CRMC DECISION WORKSHEET

2026-03-067

Applicant's Name:	Department of Environmental Management
CRMC File Number:	2026-03-067
Project:	Replacement of Pier JJ with modifications in size and number of piles. The existing 8ftx105ft pier is proposed to be removed and replaced with a new 10ftx106ft pier with 3 additional piles and 3 fewer bents resulting in an increase of 210 sq ft in size.
Location:	45 State Street; Narragansett: Plat(s): I-G; Lot(s): 266-S, 266-SXM, 96
Water Type/Name:	
Coastal Feature:	Developed Barrier, Manmade Shoreline (Steel Bulkhead)
Plans Reviewed:	"Peir 'JJ' Removal and Replacement Port of Galilee: 26005887: Phase V" dated March 26, 2026 and prepared by Pare Corporation.

PIER 'JJ' REMOVAL AND REPLACEMENT PORT OF GALILEE: 26005887: PHASE V

LOCATION PLAN
SCALE: 1"=20'

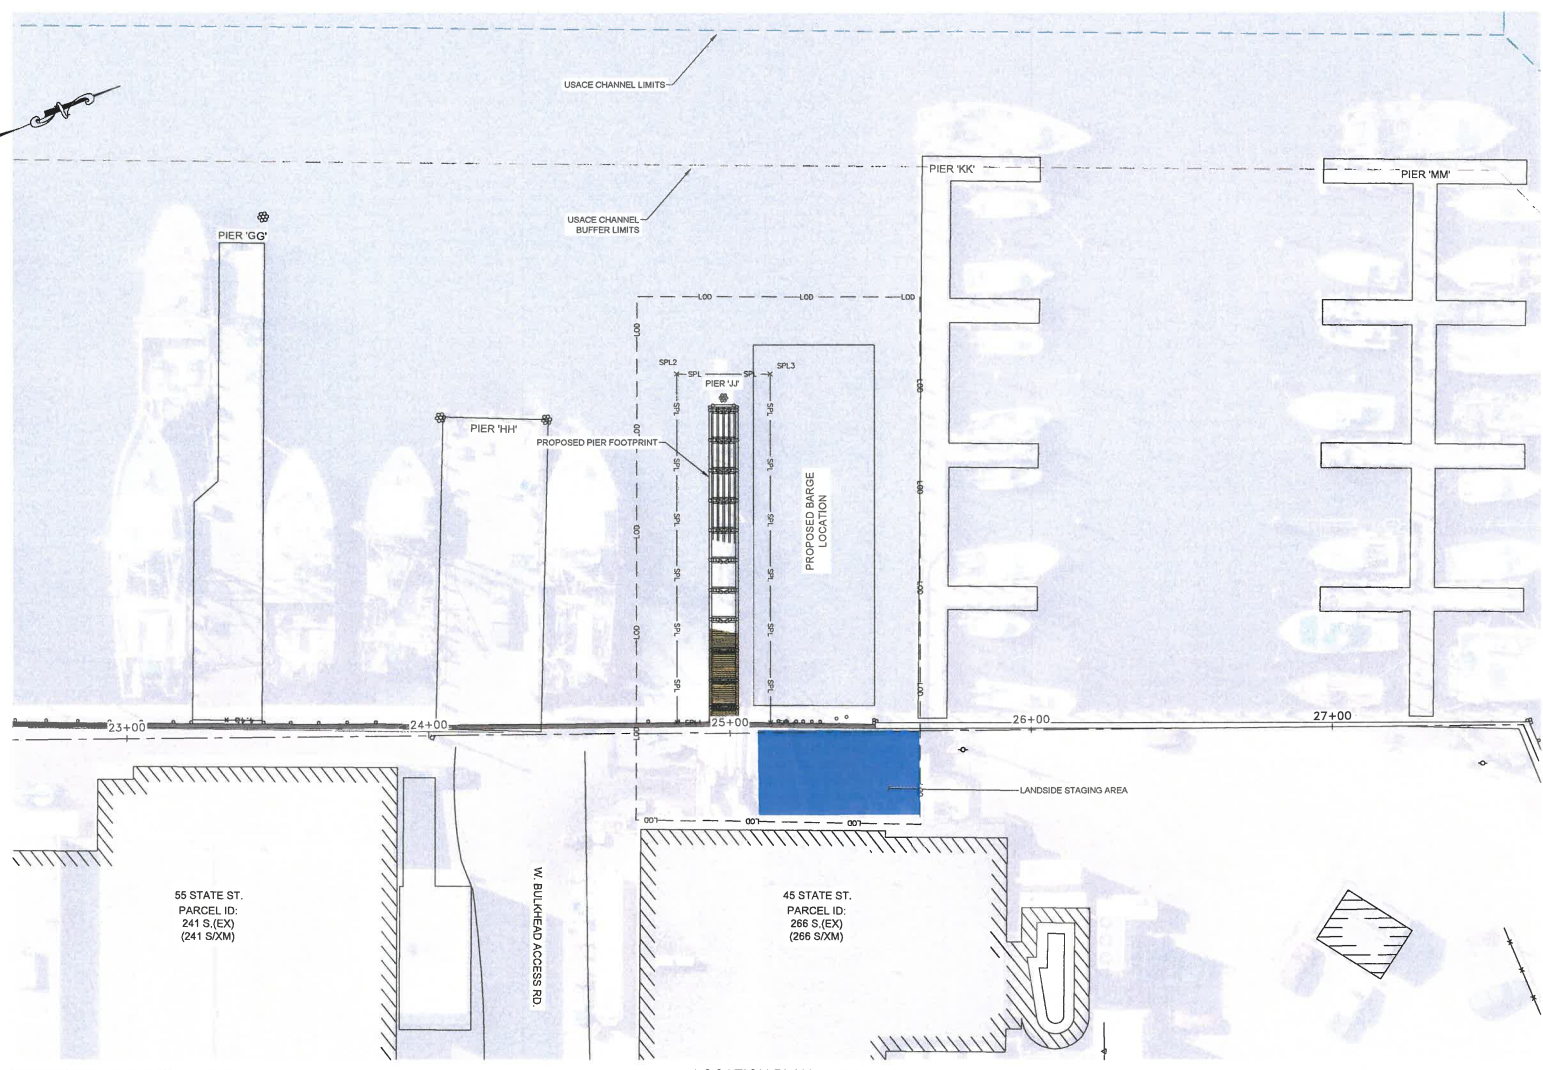
1.3.1(C)	Residential, Commercial, Industrial, and Recreational Structures	The proposed structures have been designed by a Professional Engineer and as such is certified to meet all applicable / required standards. In addition, a Structural Perimeter Limit has been addressed on the submitted plans. It is the opinion of staff that the proposal meets the policies and standards of this section of the RICRMP.
